PCN-20210616 TE0821-01 eMMC Change and Product Update

Company	Trenz Electronic GmbH
PCN Number	PCN-20210616
Title	TE0821-01 eMMC Change and Product Update
Subject	BOM change
Issue Date	2021-08-10

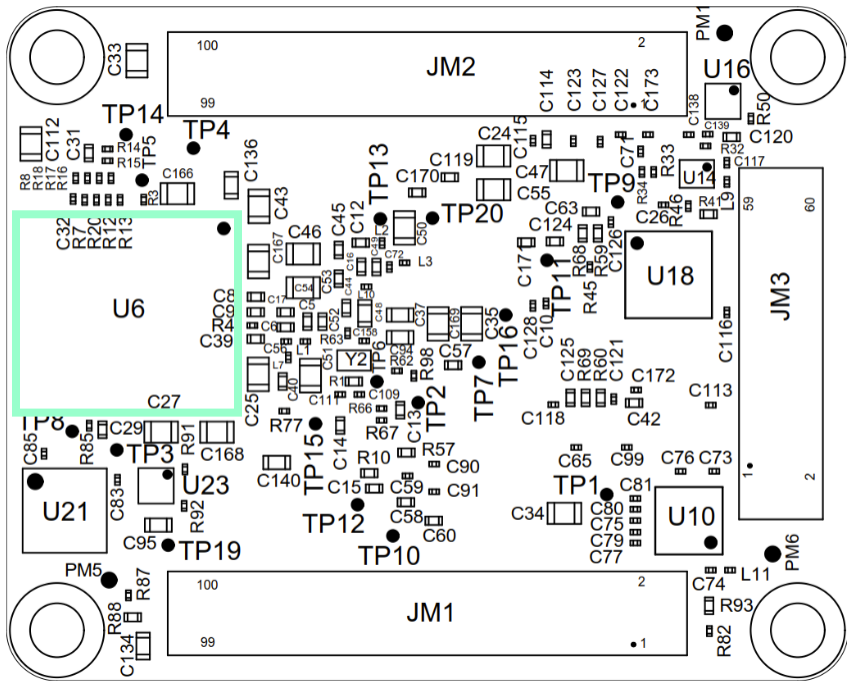
#3 Change Ferrite Beads (L1, L2, L3, L4, L5, L7, L9, L10, L11, L12) BKP0603HS121-T to MPZ0603S121HT000

Type: BOM change
Reason: Part is NRND and EOL announced.
Impact: None. DC resistance decreased from 150mOhm to 130mOhm, rated current increased from 0.85A to 1A.

Locate eMMC (U6) on bottom side of PCB:

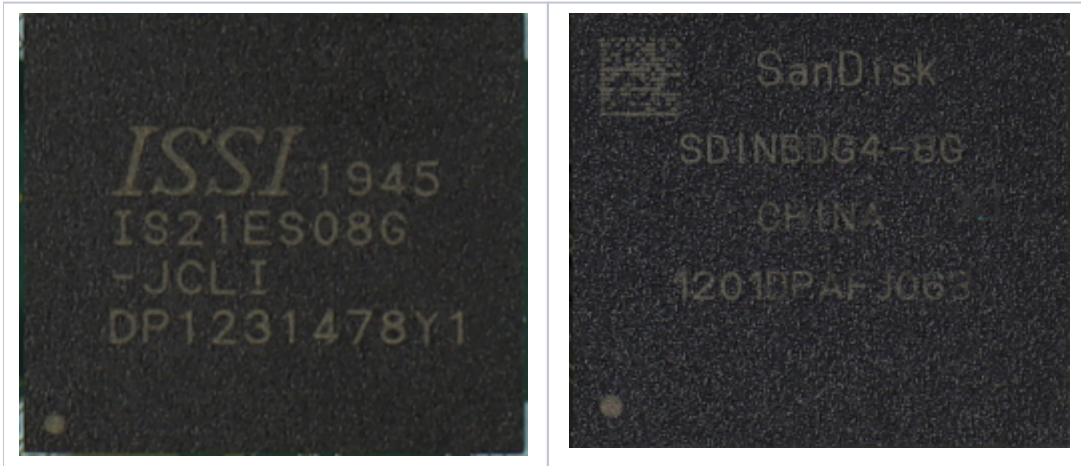
#1 Change eMMC (U6) from IS21ES08G-JCLI / IS21ES64G-JCLI to SDINBDG4-8G-XI2 / SDINBDG4-64G-XI2

Reason: Distributor informed about unforeseeable immediate EOL of parts. No official documents from manufacturer are available. No LTB, already confirmed orders were cancelled by distributor/manufacturer.

Impact: None. Replacement has same capacity as used on corresponding affected variant. Reference designs for vivado versions 2019.2 and 2020.2 were tested and work properly without any changes.

old	new
IS21ES08G-JCLI or IS21ES64G-JCLI	SDINBDG4-8G-XI2 or SDINBDG4-64G-XI2
